Subject: Comments on Final Resource Reports for the Mountain Valley Pipeline Project
OEP/DG2E/Gas 3
Mountain Valley Pipeline, LLC
Docket No. CP16-10-000

Forest Service Comments on Final Resource Reports Dated October 2015

Mountain Valley Pipeline Project (Docket No. CP16-10)

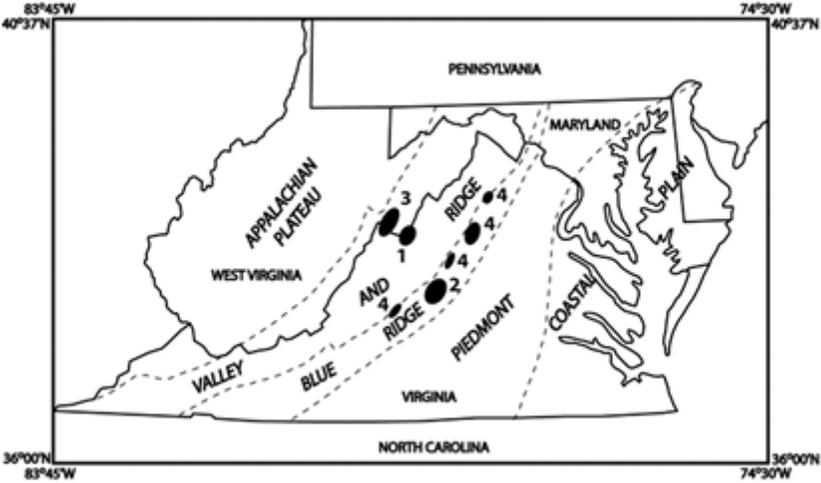
6	6-23	6.4.1.5	<p>Describe historic accounts of landslides from the May 31, 1897 earthquake. It is important to find out as much as possible about these landslides because these types of landslides will likely be common with earthquakes of similar or greater magnitude.</p> <p>In addition, consider potential for landslides generated by earthquakes with epicenters outside the GCSZ or PFZ, such as described by Jibson and Harp, 2012.</p> <p>Jibson, R.W and Edwin L. Harp, E.L., 2012, Extraordinary Distance Limits of Landslides Triggered by the 2011 Mineral, Virginia, Earthquake, Bulletin of the Seismological Society of America, Vol. 102, No. 6, pp. –, December 2012, doi: 10.1785/0120120055</p>
6	6-23	6.4.1.5	<p>Identify the large rock block landslides on Sinking Creek Mountain. The pipeline corridor traverses the JNF on the southeast flank of Sinking Creek Mountain. A series of large rock block slides extends for miles along the southeast flank of Sinking Creek Mountain (Schultz, A.P., 1993). Schultz (1993) states that the analysis shows that the rock block slides may have been emplaced as a single catastrophic event of short duration. Schultz and Southworth (1989) state: “The apparent clustering of large landslides near the Giles County, Virginia seismic zone suggests that seismic shaking may have been an important triggering mechanism.”</p> <p>Whisonant, Watts, and Kastning (1991) did a study of landslides in the Giles County Seismic Zone (GCSZ) and identified landslides on Sinking Creek Mountain and elsewhere as landslides likely to be of seismic origin or to contain evidence of seismic events.</p> <p>Review and discuss the studies which have considered earthquakes as a triggering mechanism for the large rock block landslides on Sinking Creek Mountain, such as:</p>
